# Health Consultation

WASTE MANAGEMENT - BROOKFIELD  
(a/k/a WASTE MANAGEMENT OF WISCONSIN, INCORPORATED)

JUNE 10, 2004

**Waste Management - Brookfield**  
Brookfield, Waukesha County, Wisconsin

Figure 3: Gas Wells in Current Monitoring Program.

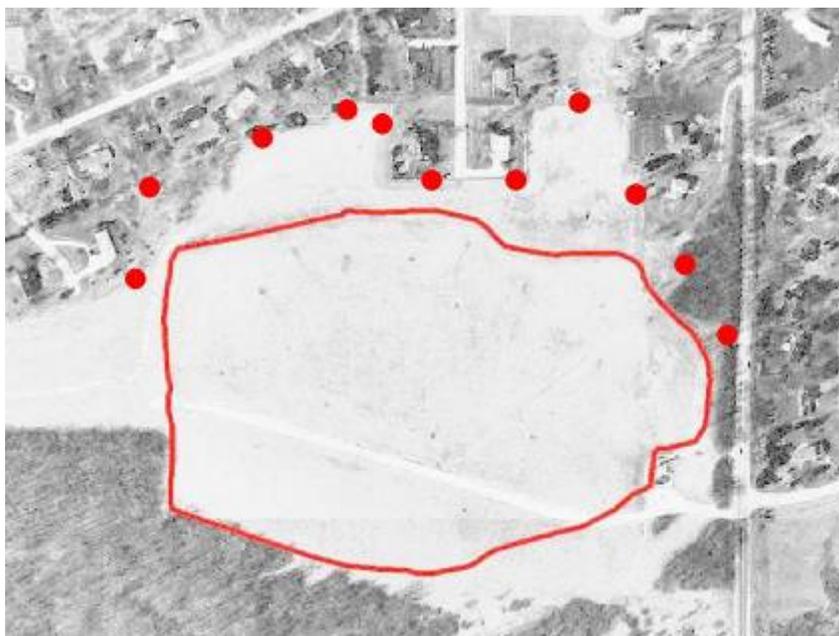
None of the monitoring points were located between the proposed development and the waste limits of the landfill. Some gas wells were present in these areas. However, they had not been monitored in many years, so long-term monitoring data were not available in these areas. Due to this lack of data, no recommendation on the appropriateness of residential development could be made in October 2003.

In October of 2003, the agencies recommended that WMWI conduct additional investigation of landfill gas between the landfill and the areas where residential lots were proposed. The agencies also recommended sampling of existing gas monitoring points that had not been routinely monitored. WMWI has conducted much of this additional investigation as requested and some of that investigation is ongoing at this time.

Figure 4: General location of numbered lots for discussion,

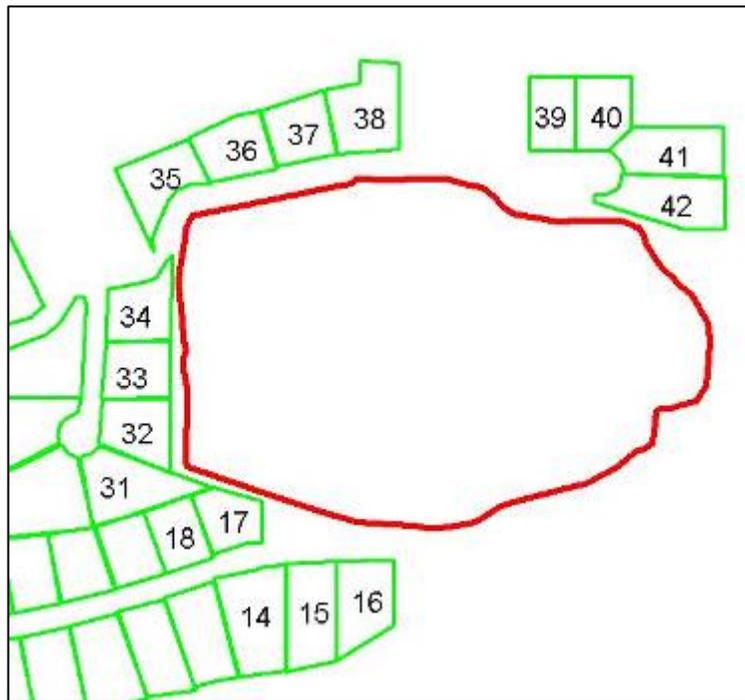
The agencies' next task is to determine the portions of the proposed plat that are affected by this finding. Lots 37, 38, and 42 had measurable levels of methane on the lot on at least one occasion. While only three lots north of the landfill have had methane measurements, the agencies do not have enough monitoring data to make a decision regarding residential development for the remaining fourteen lots numbered in Figure 4. The variability in methane measurements within short distances on the north side of the landfill, combined with low level detections of methane in some near landfill areas, indicates that a greater number of gas monitoring wells, monitored over a longer period, are needed in order to make a decision about development.

In light of the methane detections in some areas near the landfill, WMWI has indicated they plan to work to modify or upgrade parts of the gas extraction system in the landfill. The Developer has voluntarily agreed to place the numbered lots identified in Figure 4 into outlots at this time. The plat will be revised to include only the 25 lots on the western portion of the property. Under the revised plat, another plat review process would be needed prior to the

Indications of landfill gas migration were also found in areas where three residential lots were proposed. Because methane, which can pose a public health hazard if it accumulates in a building, was found on three lots, the developer has agreed with the agencies that lots 14-18 and 31-42 initially proposed for development will be designated as outlots on the pending preliminary plat. The developer has the option of going through the plat/development process for those outlots again in the future. Based on existing environmental data and the recent landfill gas investigation, the development of lots 1-13 and 19-30 (the westernmost lots) poses no public health hazard to residents as a result of accumulation of indoor methane gas.
